PERFORMANCE BULLETIN 135

Stager Motor Update

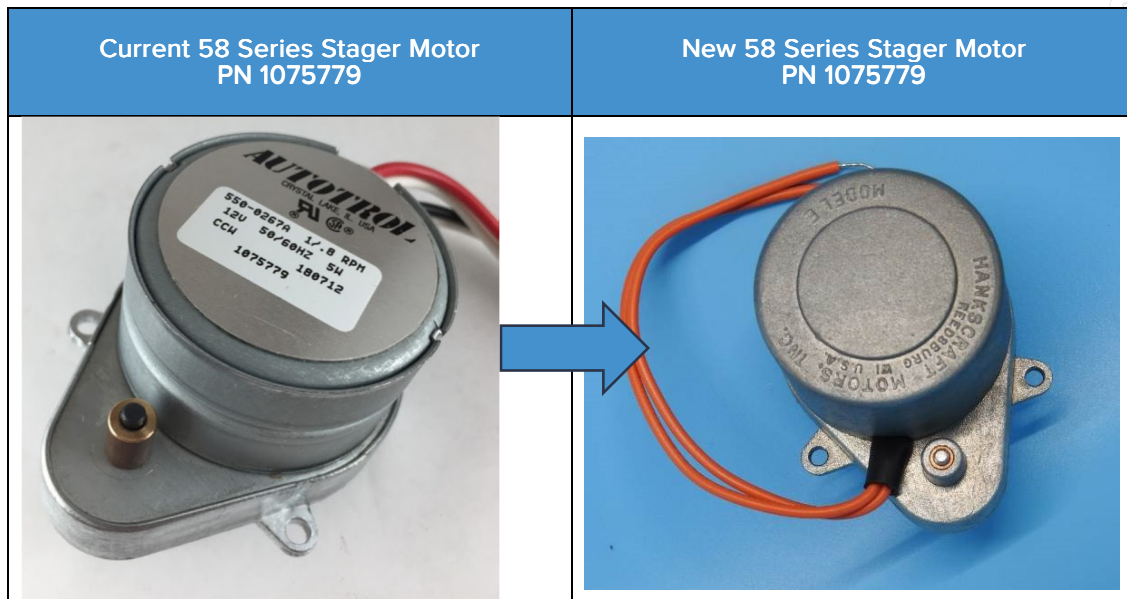
Due to a supply outage on Autotrol brand Stager motors, AQ Matic is transitioning to a new motor manufacturer, Hankscraft. The new motors have slightly higher torque and are a direct replacement to the current except the new motors do not have a clutch. Because they do not have a clutch, **the new motors cannot be rotated by hand.**

If manual rotation of the stager is required with the new motors shown above, the two motor mounting screws will need to be removed and the motor disengaged from the stager cam.
